DYNE HOUSE REVIEW OF BUILDING DAMAGE ASSESSMENT REPORTS

REPORTS REVIEWED

1. Expedition: Highgate School Dyne House and Island Site Basement Impact Assessment EXP-REP-404-001Rev 00 Parts 1 to 6.
2. Expedition: Highgate School Dyne House and Island Site. Basement Impact Assessment EXP-REP-XXX-001. Rev 03

Figure 6.17 Relationship between analysed lateral (propped) wall deflections and predicted ground surface settlements in stiff ground

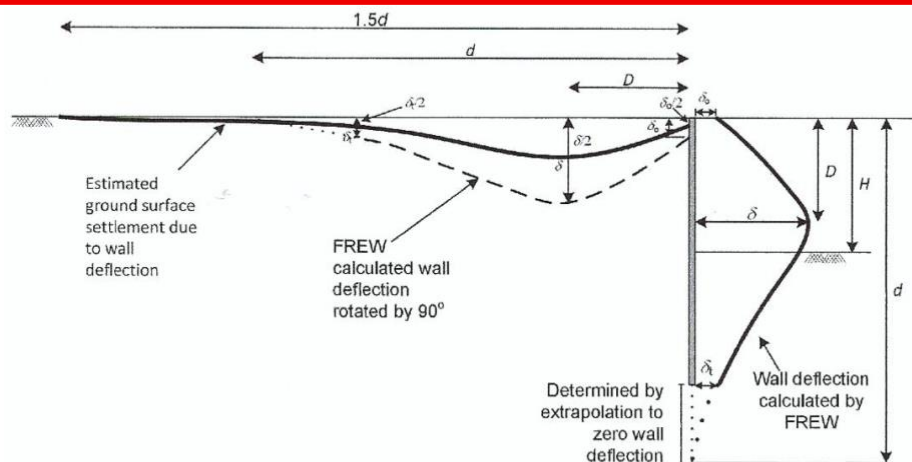
“For walls embedded in competent (stiff) ground back analysis of case study data relating to excavations at the YMCA (16m deep) and New Palace Yard (18m deep) in London, using FREW yields the approximate relationship shown in Figure 6.17. This relationship is based on the case studies that comprise a top-down construction sequence with diaphragm walls embedded in stiff clay retaining up to 10m thickness of coarse-grained soils overlying the stiff clay. The relationship shown in Figure 6.17 should only be applied in comparable ground conditions with similar support stiffness. Caution should be exercised if this relationship is applied to situations that differ significantly from those applicable to the case studies that it is based on.”

9. It is apparent that the proposed scheme at Dyne House differs somewhat from the case histories that this procedure was based on (the YMCA on Tottenham Court Road and the New Palace Yard in Westminster) and as CIRIA C760 suggests, caution should be exercised. Further, the ground is sloping from one side of the new basement to the other and is not level as the BIA assumes. As such the approach adopted is not appropriate.

10. CIRIA C760 describes other forms of analysis (finite difference and finite element) which can account for the level changes across the site and how these impact on the behaviour of the retaining structures. With appropriate representation of the ground response, these methods of analysis account for the overall sway of the basement from upslope to downslope. They can directly give displacements remote from the excavation that can be used to assess potential building damage although, depending on the detail of the analysis, displacements caused by changes in the groundwater regime may need to be added. Such methods of analysis do not rely on the procedure described in Appendix B.

11. As previously noted, an approach has been adopted for the BIA (Revisions 00 & 03) which is not appropriate in this case. Suitable forms of analyses (finite difference and finite element) are routinely undertaken by geotechnical engineers and there is no reason why these approaches could not have been adopted in this instance.
